**Economic and Social Council**Distr.: General
27 February 2014

Economic Commission for Europe**Inland Transport Committee****World Forum for Harmonization of Vehicle Regulations****Working Party on Passive Safety****Fifty-fifth session**

Global technical regulation**No. 9 (Pedestrian safety) – Proposal for amendments to Phase 1 and draft Phase 2****Proposal for amendment to draft Phase 2 to global technical regulation No. 9 (Pedestrian safety)****Submitted by the expert from the European Commission***

"Figure 6A

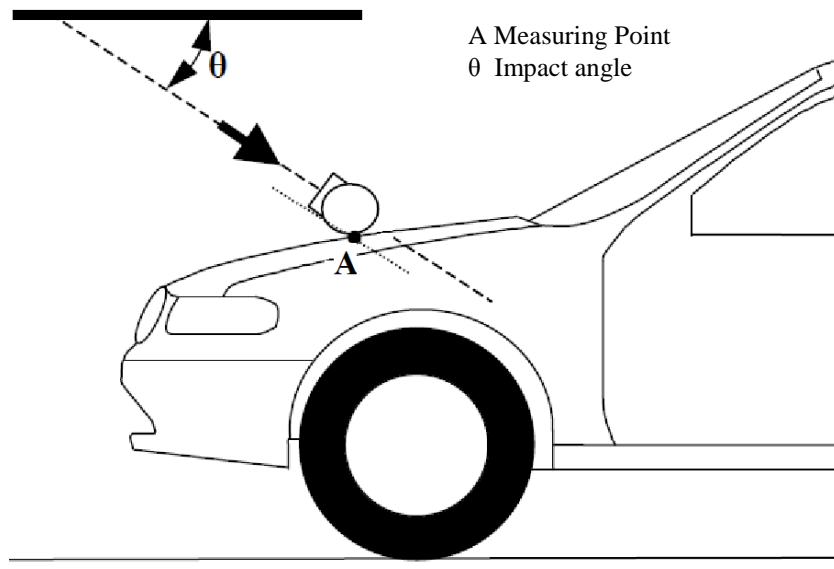
Insert new Figures 6A and 6B, to read:

Measuring point in the vertical longitudinal plane through the centre of the headform impactor (see paragraph 3.20.1.)²

² Note: due to the spatial geometry of the bonnet top, the first contact may not occur in the same vertical longitudinal or transverse plane which contains measuring point A.

"3.20. "Measuring point"

The measuring point is may also be referred to as "test point" or "impact point". In all cases, the result of the test shall be attributed to this point, independent of where the first contact occurs.

3.20.1. "Measuring point" for the headform test means a point on the vehicle's outer surface selected for assessment. The measuring point is where the headform's profile contacts the vehicle's outer surface cross section in a vertical longitudinal plane through the center of gravity of the headform (see Figure 6A).

"Figure 11

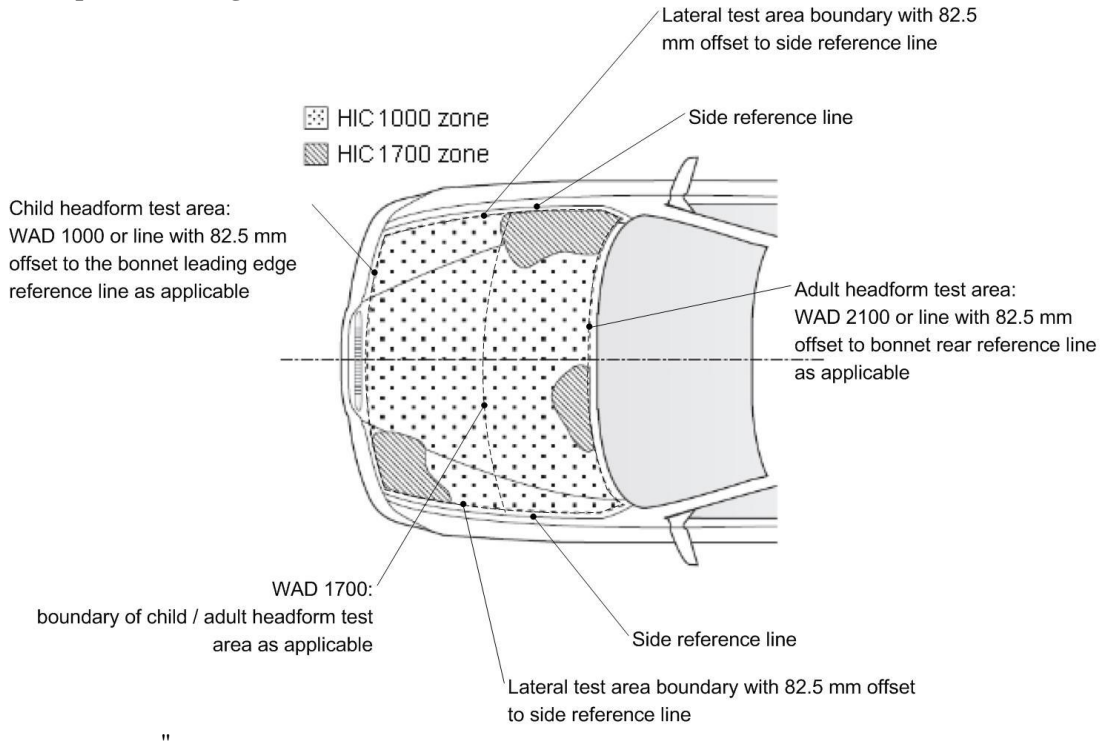
Figure 11(former), shall be deleted

Insert new Figure 11, to read:

Example of marking of HIC1000 zone and HIC1700 zone

"5.2.4.1. The manufacturer shall identify the zones of the bonnet top **test area** where the HIC must not exceed 1,000 (HIC1000 Zone) or 1,700 (HIC1700 Zone) (see Figure 11)."
